Access Compliance Report

Public Rights-of-Way

(Pedestrian Signals)

Intersection ID: N/A	Main Street:	Cross Street: N/A	Location: N/A
ADA ID: BEB246C6D38E	Signal Type: One Push Button-Non APS	Overall Compliance: No	Severity Score: BTN 1: N/A BTN 2: N/A No BTN: N/A
Codes/Mitigation Info/Possible Solution		Field Measurements/Component Compliance

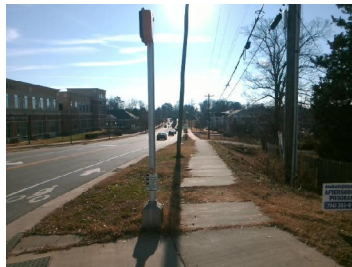
Surveyor Notes: Clear floor space within curb ramp

PROW/ADA: R209.1, TMUTCD 4e.08, R404.2, R404.3

Possible Solutions: Replace Signal Push Button With APS Button on New Post.
